Release Note

Edgecore EAP104 Release v12.1.0

Document # EAP104-v12.1.0-760-6f3567ae

Enhancement from v12.0.0-662-acc0cdd8

1.2 SNMP Read Community

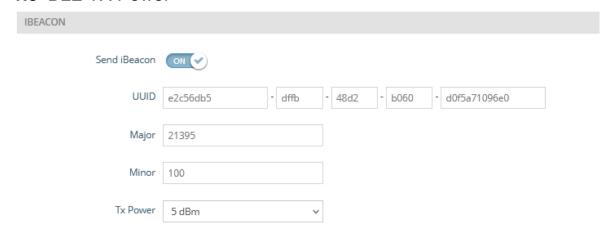
Support SNMP read community on the Services page of System.

The following items are displayed on this page:

- Read Community A community string that permits read access to the access point's Management Information Base (MIB).
- 2. IPv6 Read Community A community string that permits IPv6 read access to the access point's Management Information Base (MIB).
